UNITED STATES PATENT AND TRADEMARK OFFICE

10/711,326

Office Action Summary	Application No. 10/711,326	Applicant(s) NAKANO ET AL.	
	Examiner THOMAS W. IRVIN	Art Unit 3683

Figs. 1 and 2 (US Patent 3,168,836)

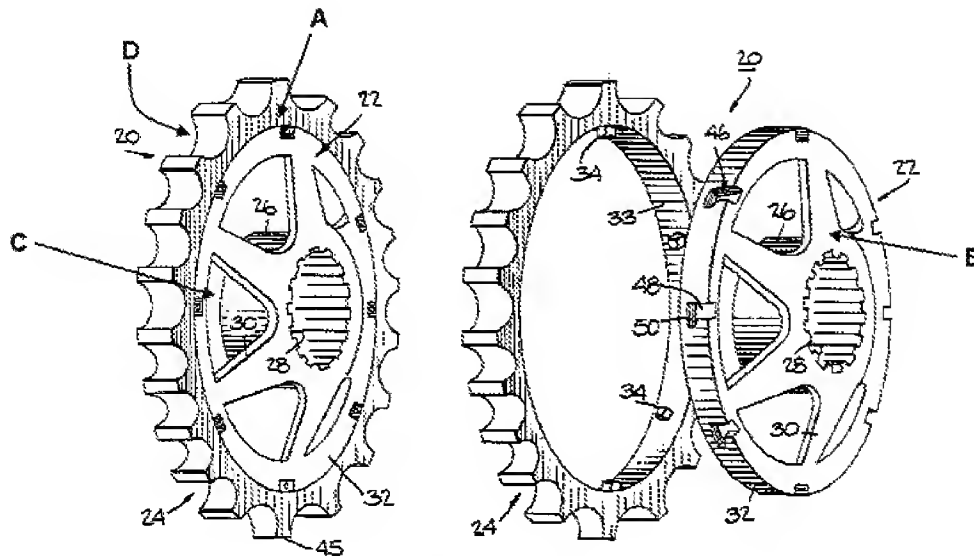
Claims 1, 3-11, and 13 are rejected under 35 U.S.C. 102(b) as being anticipated by Militana (3,168,836).

In Re claim 1, with reference to Figs. 1 and 2 shown above, '836 discloses a bicycle sprocket, wherein the sprocket comprises: a sprocket body (20); a plurality of teeth (45) extending radially outwardly from the sprocket body; a spline (28) extending radially inwardly from the sprocket body; wherein the spline includes a radially outer surface (26) facing radially outwardly; and wherein the radially outer surface of the spline faces a radially inner surface (33) of the sprocket body.

In Re claim 3, the inner surface is substantially straight in a direction of the rotational axis.

In Re claim 4, the inner surface is substantially parallel to the rotational axis.

In Re claim 5, the sprocket body has a side wall that includes a first side wall portion (A) and a second side wall portion (B), wherein the plurality of teeth extend radially outwardly from the first side wall portion, and wherein the second side wall portion is laterally offset from the first side wall portion.

In Re claim 6, the second side wall portion overlaps the outer surface (26) when viewed in a direction parallel to the rotational axis.

In Re claim 7, the second side wall portion is spaced apart from the first side wall portion in a direction of the rotational axis.

In Re claim 8, the spline is offset from the first side wall portion in a direction of the rotational axis.

In Re claim 9, the spline extends from the second side wall portion and terminates at a free end (C), and the free end is spaced apart from a first side wall (D) of the first side wall portion (A) that faces in a same direction as the free end.

In Re claim 10, the sprocket body has a side wall that includes a first side wall portion (A) and a second side wall portion (B), wherein the plurality of teeth extend radially outwardly from the first side wall portion. It is the examiner's understanding that the second side wall portion and the spline together form a composite spline.

In Re claim 11, a thickness of the spline in a direction of the rotational axis is greater than a thickness of the second side wall portion in a direction of the rotational axis.

In Re claim 13, with reference to Figs. 1 and 2 shown above, '836 discloses a bicycle sprocket, wherein the sprocket comprises: a sprocket body (20); a plurality of teeth (45) extending radially outwardly from the sprocket body; a spline (28) extending radially inwardly from the sprocket body, wherein the spline has a root portion (30) and a radially inner portion (26), wherein the root portion extends radially inwardly of the sprocket body and has a side wall (B) facing in a rotational direction, and wherein the

radially inner portion extends radially inwardly of the root portion and has a side wall (C) facing in the rotational direction; and wherein a thickness of the radially inner portion of the spline in a direction parallel to the rotational axis is greater than a thickness of the root portion of the spline in a direction of the rotational axis.
